Re: SCP-Carlstadt

This is in response to your September 11, 1986 letter to Janet Feldstein of my staff, regarding EPA's comments on Dames & Moore's Draft Project Operations Plan ("POP"). As Janet told you when you spoke September 18, 1986, EPA feels that your letter requires some clarification.

Comments on September 18, 1986 Draft Project Operations Plan

ATTACHMENT III  
NEW JERSEY DEPARTMENT OF ENVIRONMENTAL PROTECTION  
UNCONSOLIDATED MONITOR WELL SPECIFICATIONS FOR  
CONFINED AQUIFERS

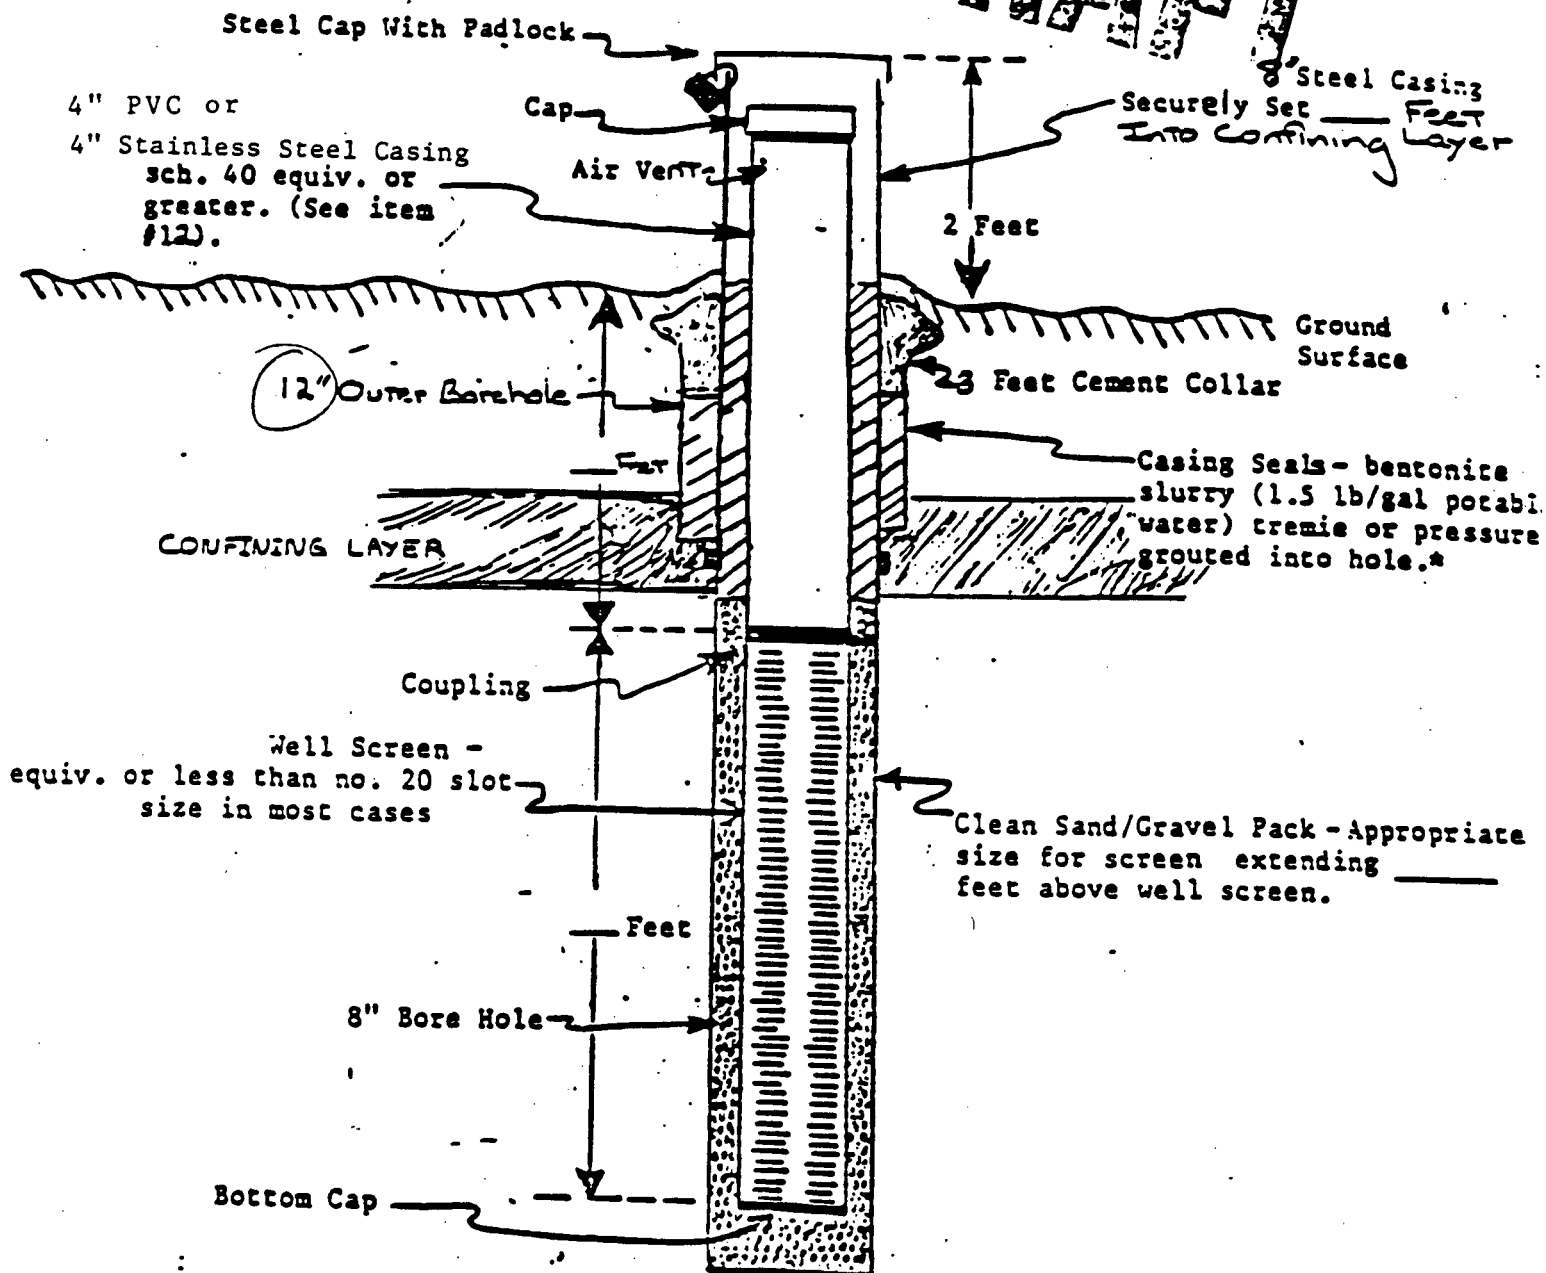
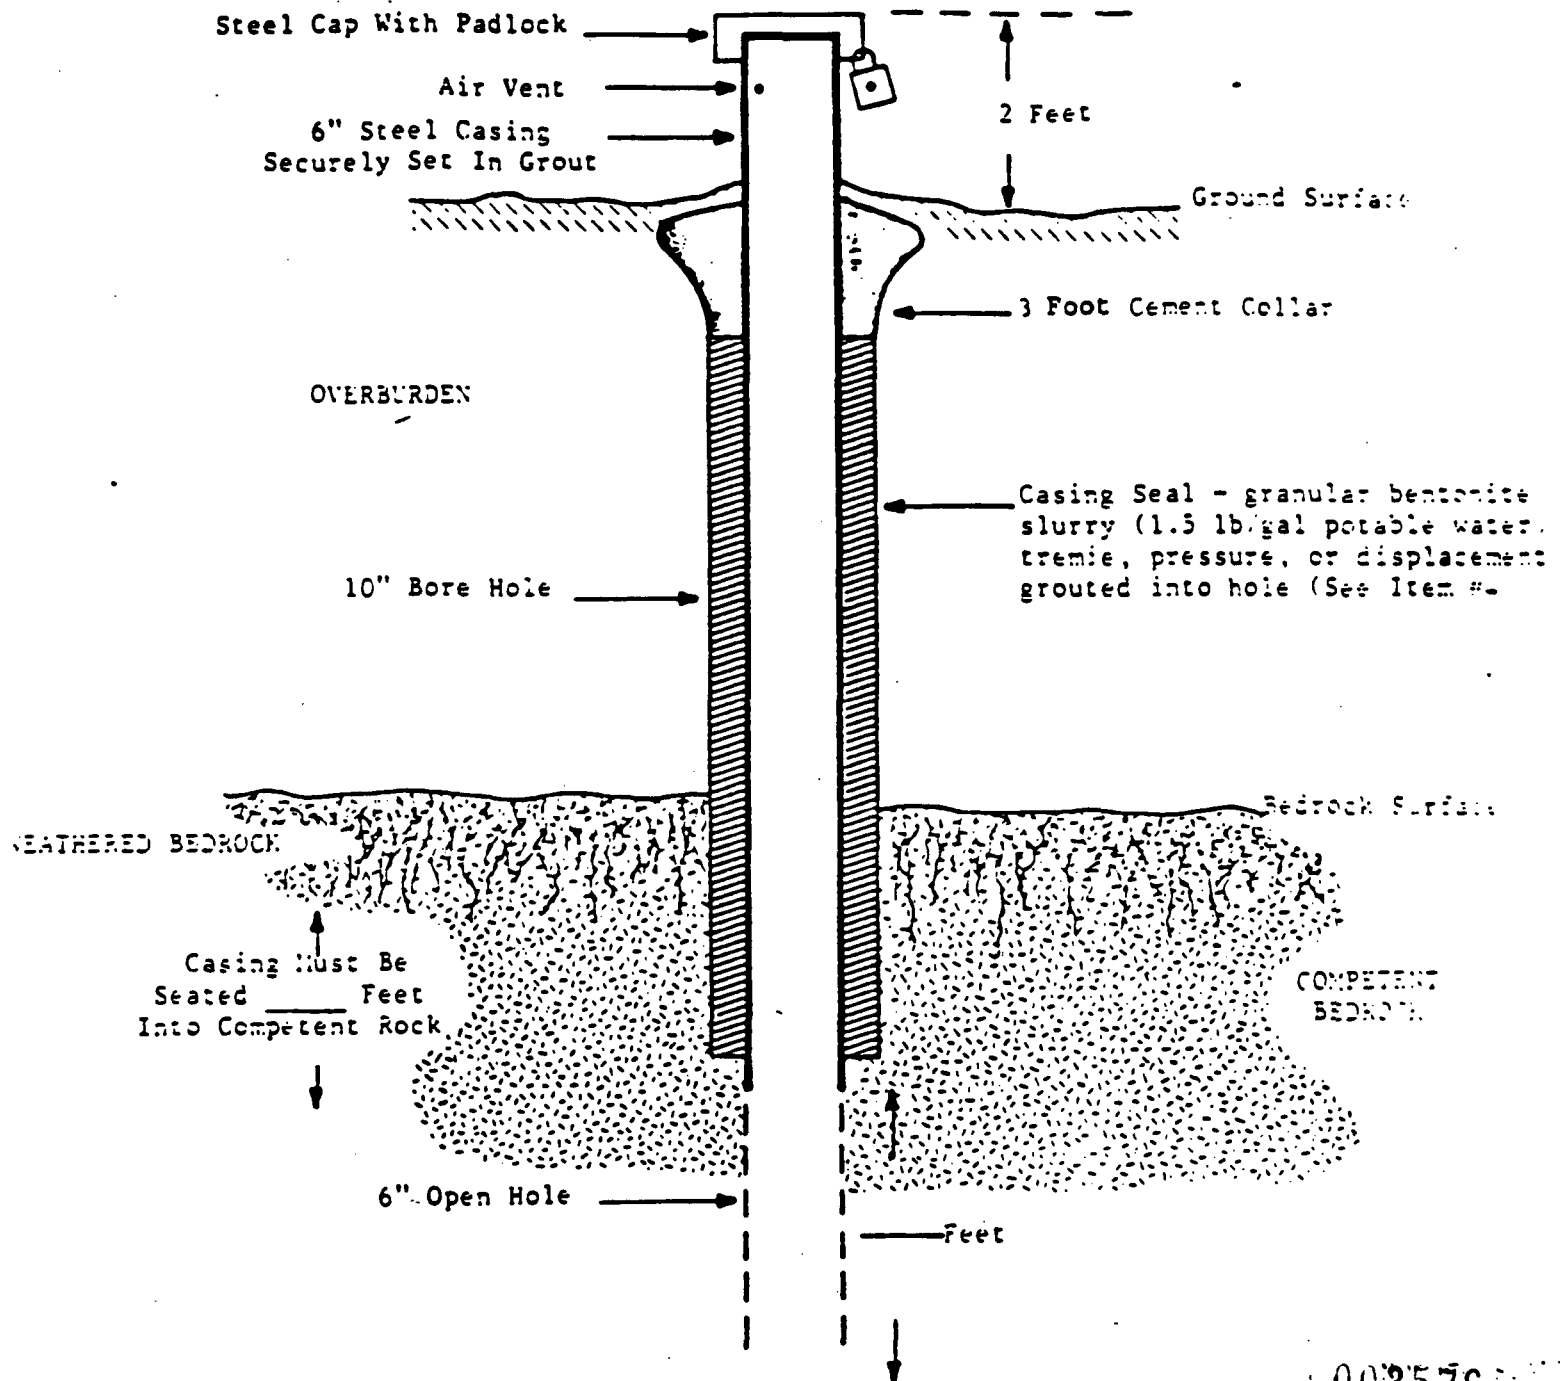
NJDEP has informed EPA that their permit specification for double cased wells include an 8 inch outer casing and riser pipe, not the 6 inch outer casing identified in this figure. Attached is the information NJDEP has provided to EPA regarding their well construction requirements.

NJDEP Division of Water Resources has asked that EPA relay the following information regarding the acceptable grouts:

- a) Cement and 5% Bentonite- max of 8 gals of potable water per 94 lb. bag of bentonite (5%)
- b) Cement and 10% Bentonite- max of 10 gals of potable water per 94 lb. bag of bentonite (10%)
- c) Neat Cement- max of 6 gals of potable water for 94 lb. bag of bentonite.
